DART AEROSPACE LTD	Work Order:	99464
Description: Crosstube Assembly	Part Number:	D206-667-243
Inspection Dwg: D206-667-243 Rev: C		Page 1 of 2

CROSSTUBE ASS'Y (206L HIGH AFT)

DRAWING NO. D206-667-243	TITLE CROSSTUBE ASS'Y (206L HIGH AFT)	REV. C	DART AEROSPACE LTD ENGINEERING ORDER		D.E.O. NO. D206-667-243-C-1	SHEET NO. SHEET 1 OF 1	SCALE NTS
DRAWN <i>qp</i>	CHECKED <i>ASS</i>	MFG. APPR. <i>RB</i>	APPROVED <i>MD</i>	DE APPR. <i>#</i>			
DATE 11.07.15	DATE 11.07.20	DATE 11.07.21	DATE 11/07/21	DATE 11.07.21

REPLACE MAGNOBOND WITH PROSEAL.

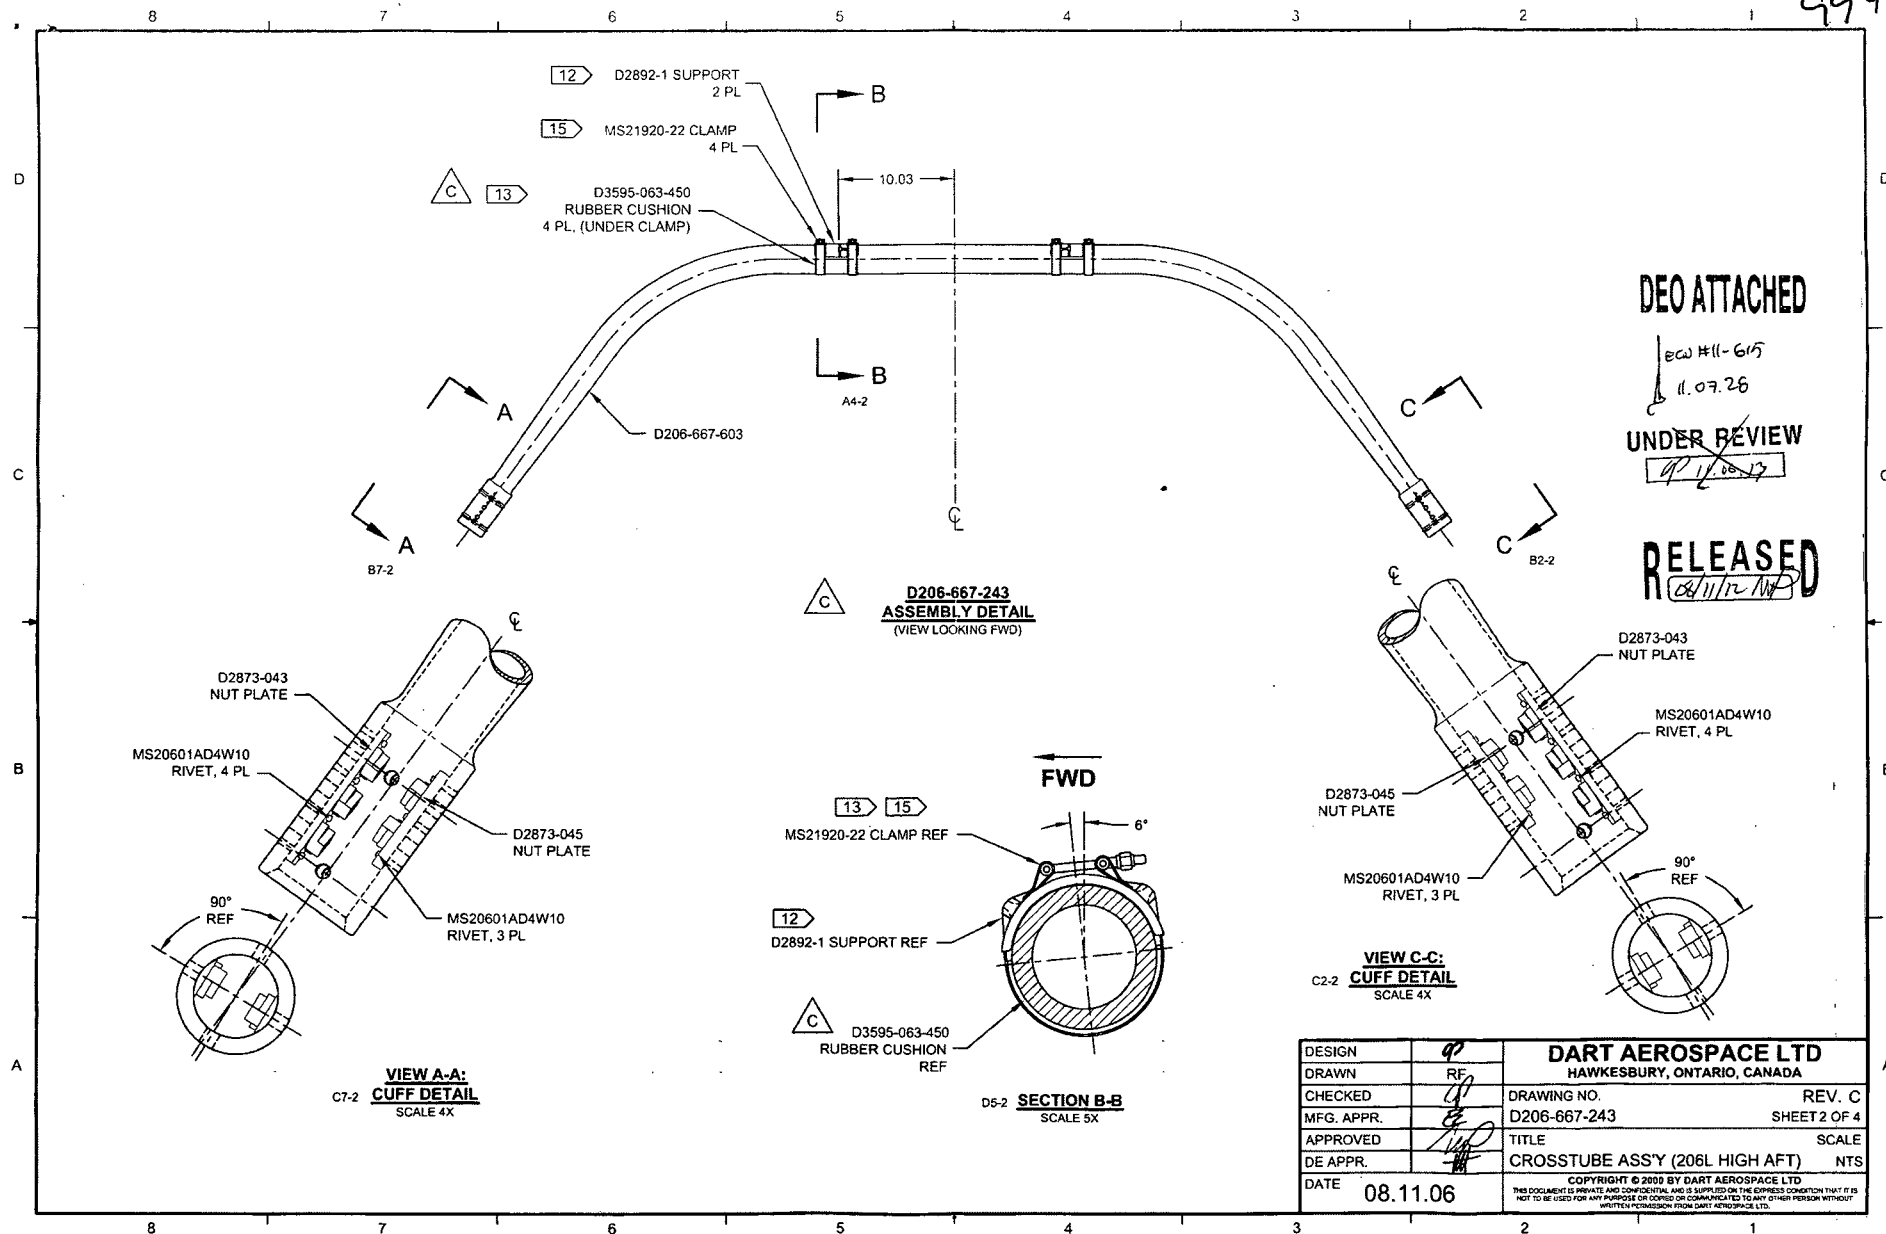
NOTE 12 & 15, SHEET 1 IS AMENDED AS FOLLOWS:

Item	Qty -243	Part Number	Description
9	A/R	PROSEAL 890 B-2	SEALANT, AMS-S-8802 CLASS B-2

- 12) TO INSTALL D2892-1 SUPPORT: ABRABE MATING SURFACE OF SUPPORT AND CROSSTUBE WITH 180-GRIT SANDPAPER AND REMOVE RESIDUE WITH MEK (OR EQUIVALENT). APPLY A 0.04" TO 0.07" THICK LAYER OF PROSEAL 890 CLASS B-2 (OR AMS-S-8802 CLASS B-2) SEALANT TO MATING SURFACE OF SUPPORT.
- 15) TORQUE CLAMPS 80 TO 100 IN-LB. ENSURE AT LEAST 1.5 THREADS SHOWING IN SAFETY AND THAT NUT HAS NOT BOTTOMED-OUT AFTER TORQUING. **PRIOR TO PACKAGING, RE-CHECK TORQUE ON CLAMPS AFTER PROSEAL 890 SEALANT HAS CURED FOR 72 HOURS.**
